ADDENDUM TO THE CONTRACT

**Bartlett Regional Hospital
MRI & CT Replacement
Contract No. BE23-042**

ADDENDUM NO.: TWO

DATE ADDENDUM ISSUED: August 3, 2022

STRUCTURAL FLOOR PLAN

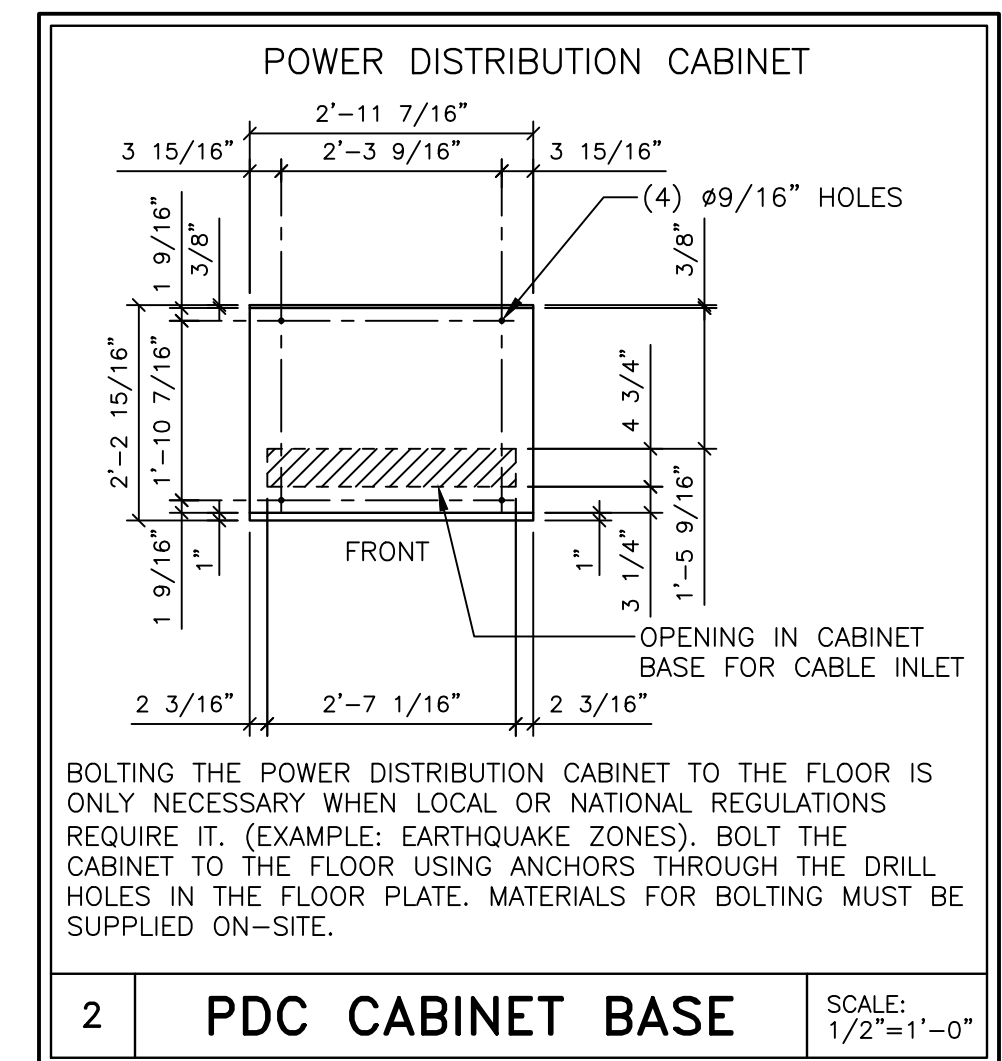
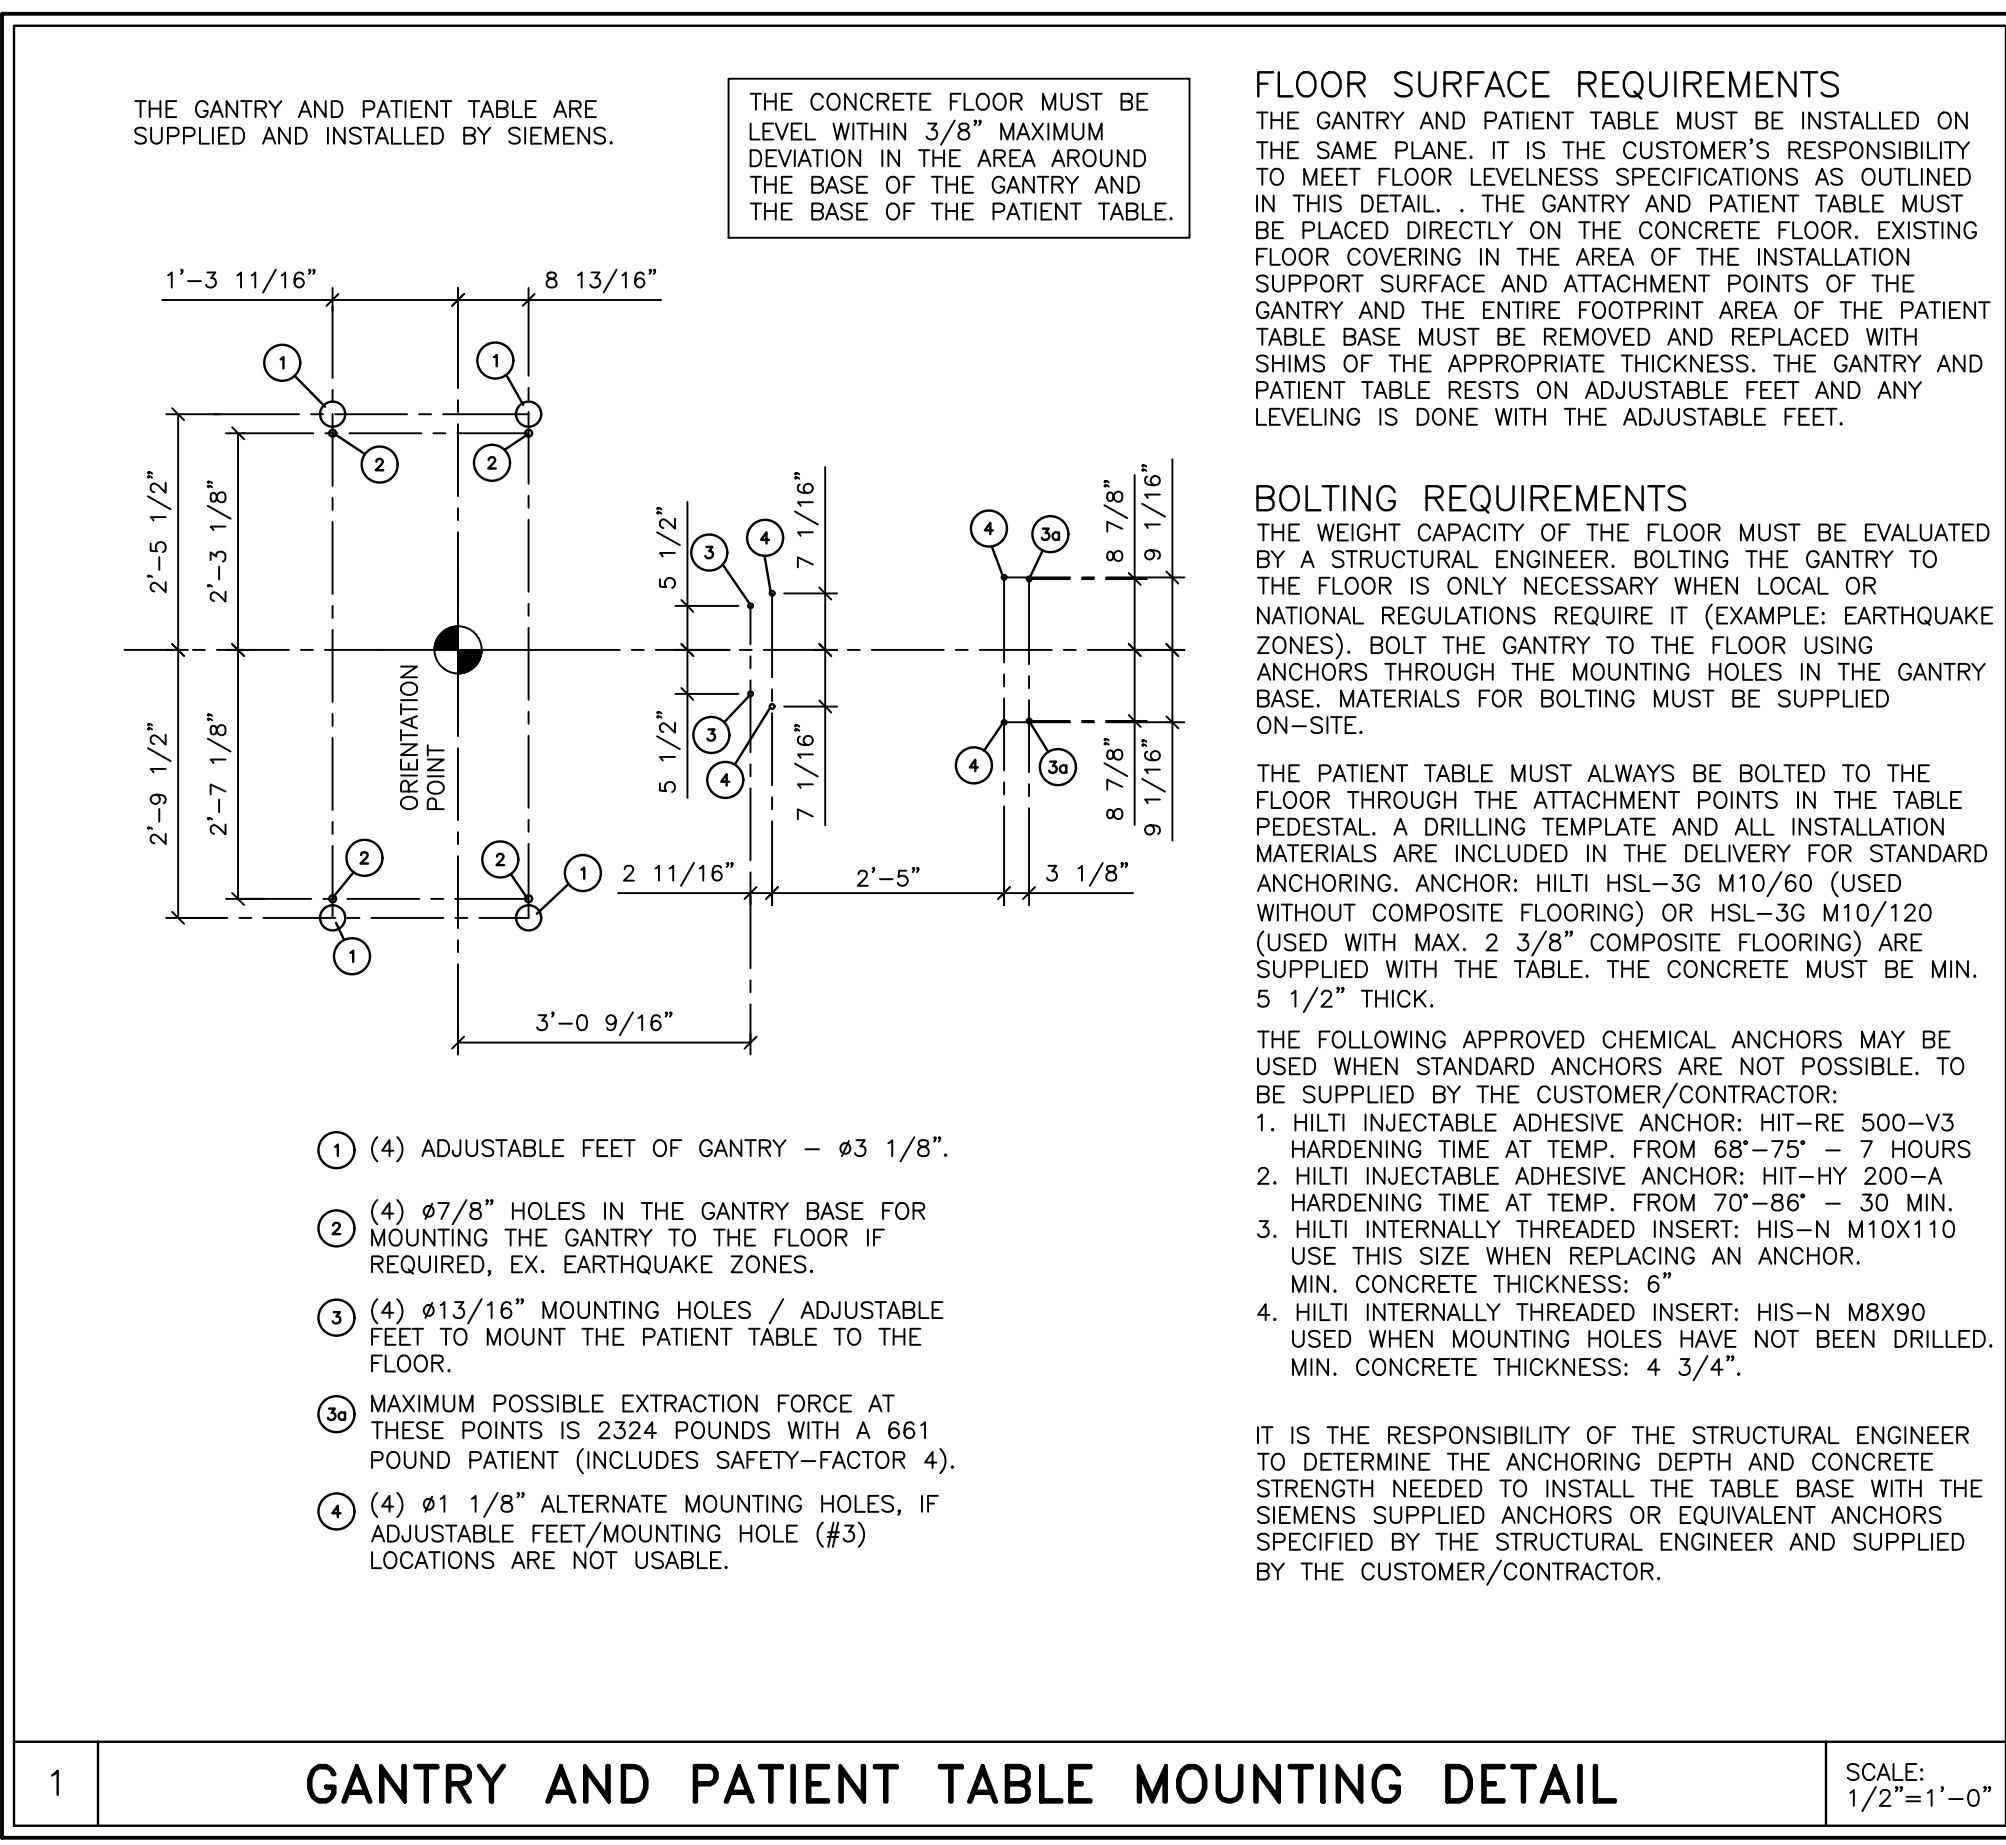
Question: "RF Shielding modifications not shown in Siemens drawings, please provide. (Sheet Flag Note 7, A104)"

Response: Please reference Siemens Detail 2/S101. There are 2 options for installing the base plate, one involves modifications to the floor directly above the RF shielding. Alternatively, all-thread may be installed through the shielding by the RF Shielding Subcontractor.
